29th Floor - M-529.00: Scope of Work and Cost Breakdown

Labor at \$125.00 per man-hour | Disconnect = removal of installed Addendum 1 work incl. haul away | Material = fabricated ductwork, fittings, insulation, accessories and air outlets | Snowflake Fitout - 7 Times Square, Floors 29-31 | COP-SF-05 Bulletin 3 Revision

NORTHERN WOLVES AC

29-1 North supply main - reroute through existing beam cuts

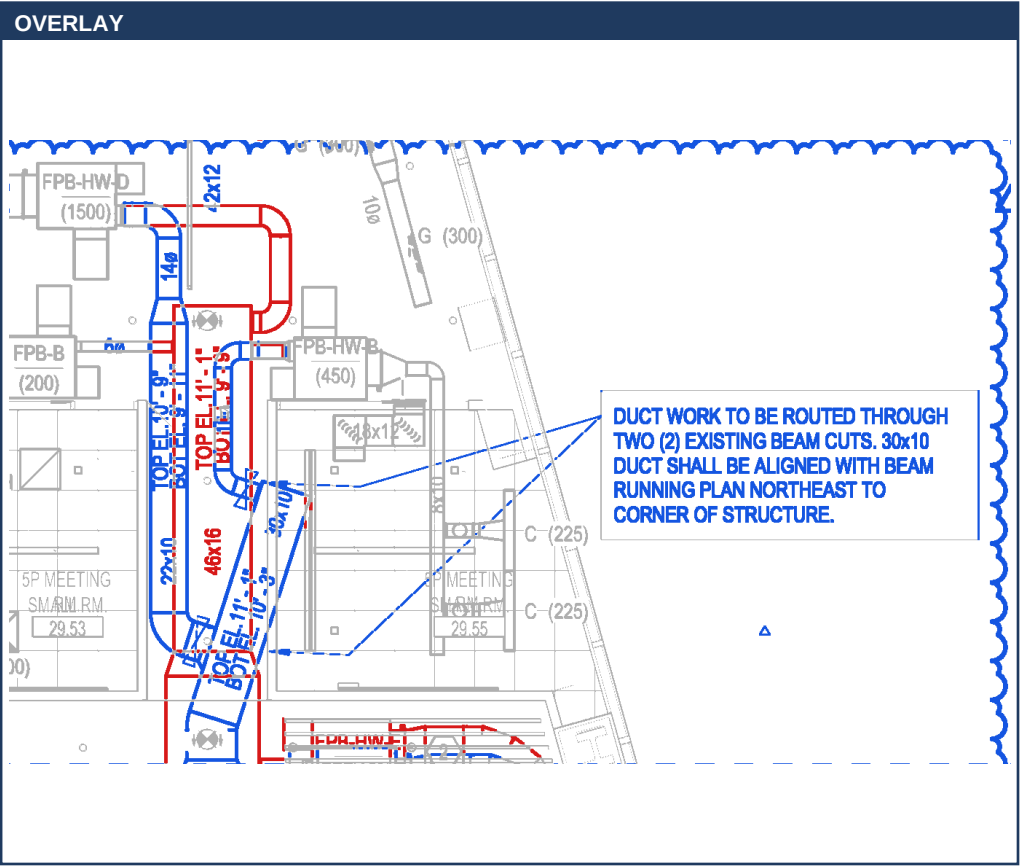
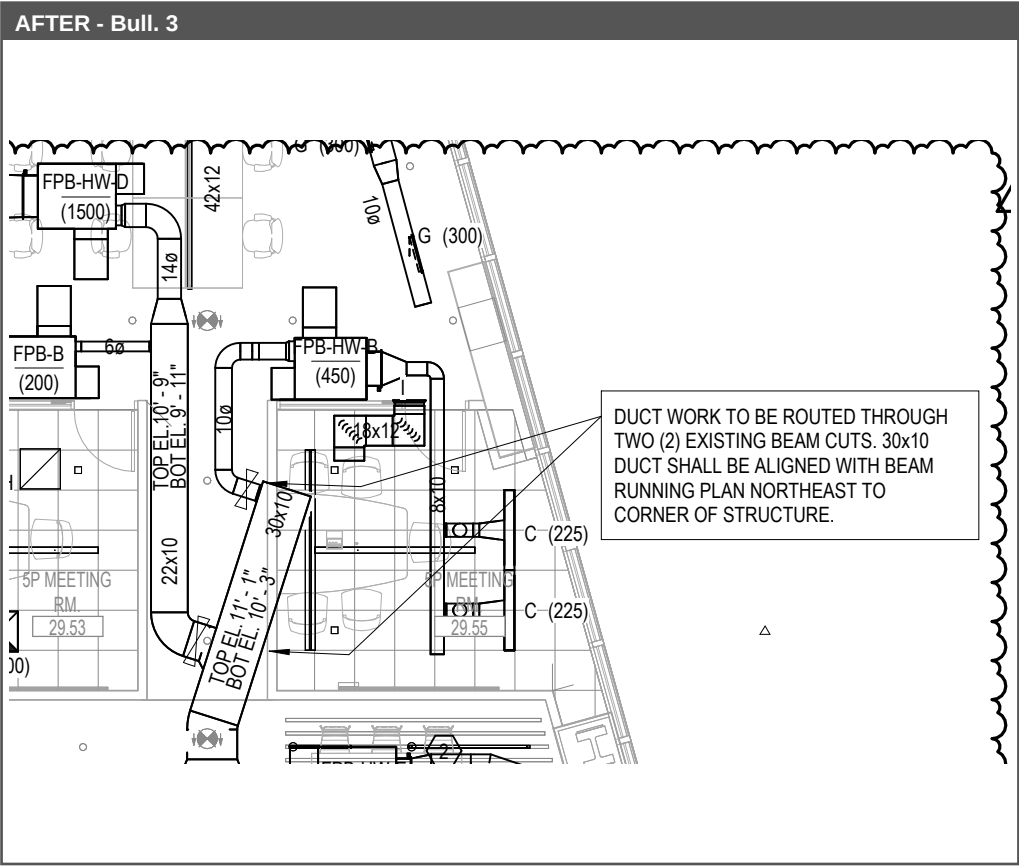
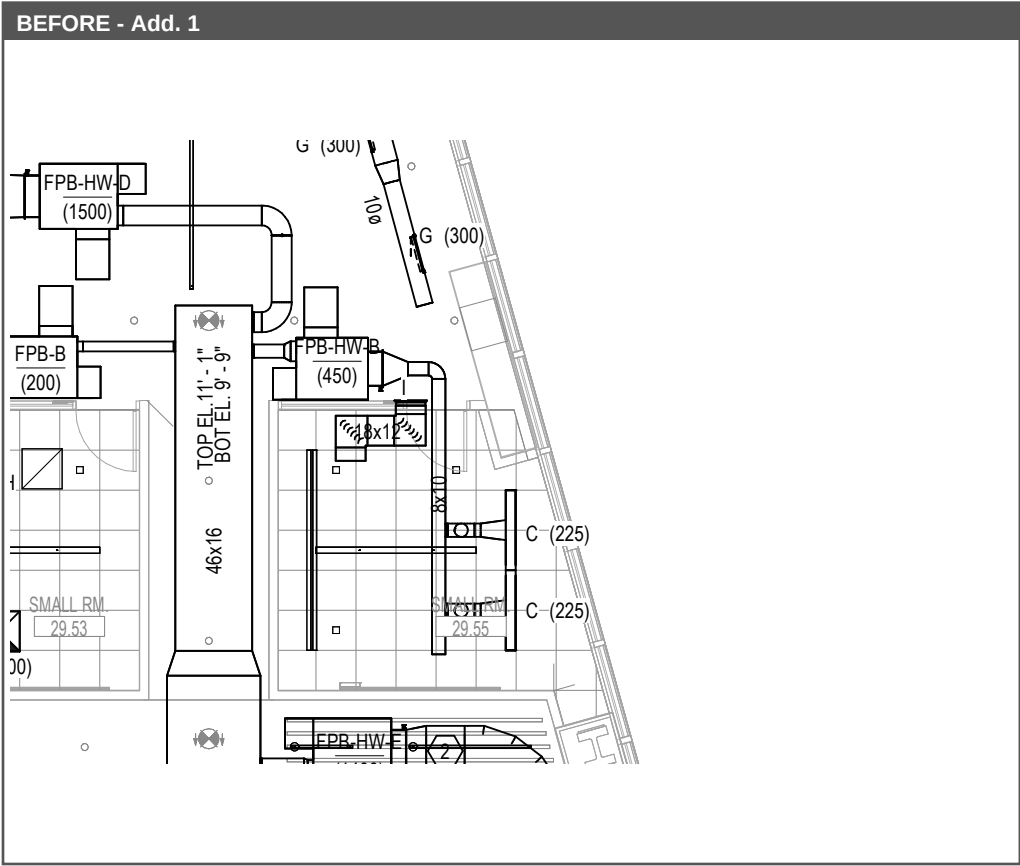
Area	Scope of work	Disconnect / removal	Material	Install labor	Total
29-1	North supply main - reroute through existing beam cuts Before: 46x16 supply main (approx. 20 LF, bottom el. 9'-9") with branch connections to FPB-HW-D (1500), FPB-HW-B (450) and FPB-B (200). After: Main rerouted as 22x10 and 30x10 through (2) existing beam cuts, 30x10 aligned with the beam running plan northeast. New 14ø branch to FPB-HW-D, 10ø to FPB-HW-B and 6ø to FPB-B. Work: Disconnect and remove installed 46x16 section and branch connections. Fabricate and install 22x10 / 30x10 duct and round branches with insulation.	12 MH \$1,500	\$4,875	60 MH \$7,500	\$13,875
29-3	FPB-HW-E (1400) relocation and discharge reroute Before: FPB-HW-E (1400) with inlet and 30x10 discharge to the G(400) / G(200) linear diffusers along the northeast wall. After: FPB-HW-E relocated; inlet connection and 30x10 discharge elbow rerouted. Work: Disconnect inlet and discharge, relocate and rehang FPB-HW-E, fabricate and install new inlet and 30x10 discharge fittings, reconnect.	2 MH \$250	\$500	6 MH \$750	\$1,500

31-1 Zoom rooms, northwest - transfers \$1,280

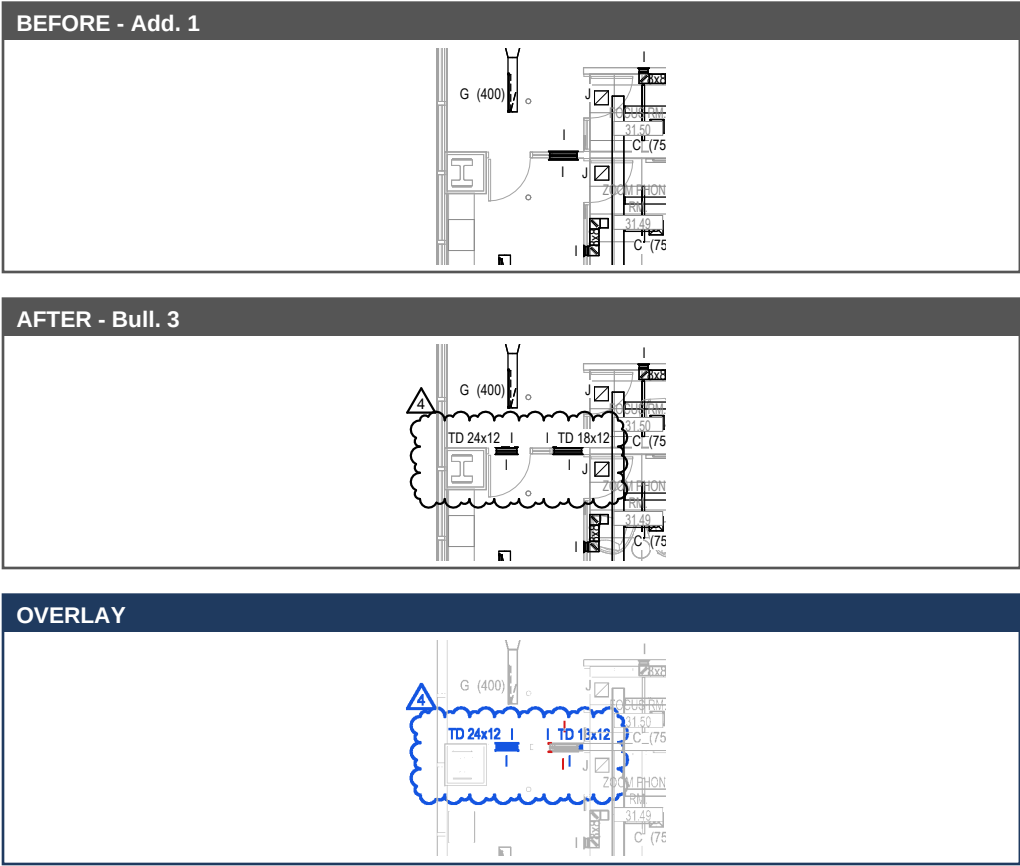
Area	Scope of work	Disconnect / removal	Material	Install labor	Total
31-1	Zoom rooms, northwest - transfers Before: (1) transfer. After: TD 24x12 and new TD 18x12. Work: Mark-up the wall openings, furnish and install (4) transfer grilles.	-	\$530	6 MH \$750	\$1,280
31-2	Transfer TD 32x16, north Before: Smaller transfer. After: New increased size for wall transfer and (2) grilles. Work: Mark-up the wall openings, furnish and install (2) transfer grilles.	-	\$300	4 MH \$500	\$800
31-3	Storage 31.02 - new transfer ducts Before: No transfer ducts. After: (2) new 44x22 transfer ducts. Work: Fabricate and install (2) 44x22 lined transfer ducts.	-	\$1,700	16 MH \$2,000	\$3,700
31-4	Coffee Bar 31.12 - transfer ducts and main fitting Before: 36x18 main with elbow at Coffee Bar 31.12; no transfer ducts. After: (2) new TD 28x16; 36x18 main elbow reconfigured. Work: Disconnect and remove 36x18 elbow; fabricate and install new fitting and (2) TD 28x16.	6 MH \$750	\$1,750	26 MH \$3,250	\$5,750

31-5 Transfer TD 32x16, southwest \$1,900

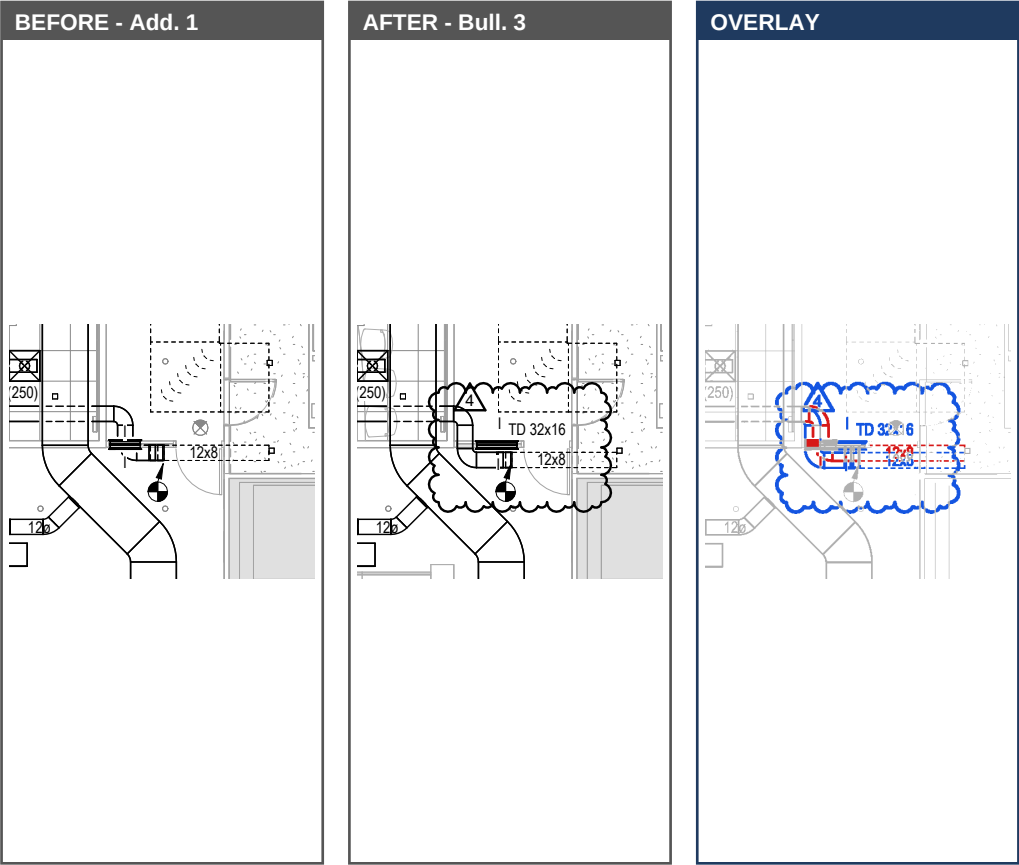
31-5	Transfer TD 32x16, southwest Before: Transfer and duct elbow as installed per Addendum 1, next to the 12x8 branch. After: Transfer revised to TD 32x16; 12x8 offset shifted to fit transfer. Work: Remove installed transfer and elbow; fabricate and install new offset, F/I (2) 32x16 transfer grilles.	2 MH \$250	\$650	8 MH \$1,000	\$1,900
31-6	Storage 31.15 / Room 31.16, southeast Before: 12x12 and 18x12 grilles at previous locations; no transfer duct at Storage 31.15. After: New TD 48x24; 12x12 and 18x12 grilles relocated. Work: Remove grilles and their duct connections; mark-up the wall openings, furnish and install (2) 48x24 transfer grilles; relocate 12x12 and 18x12 grilles with duct connections at new locations.	4 MH \$500	\$600	12 MH \$1,500	\$2,600
	Shop drawings for revised design				\$1,000
	31st floor total (12 MH disconnect, 72 MH install)	\$1,500	\$5,530	\$9,000	\$17,030
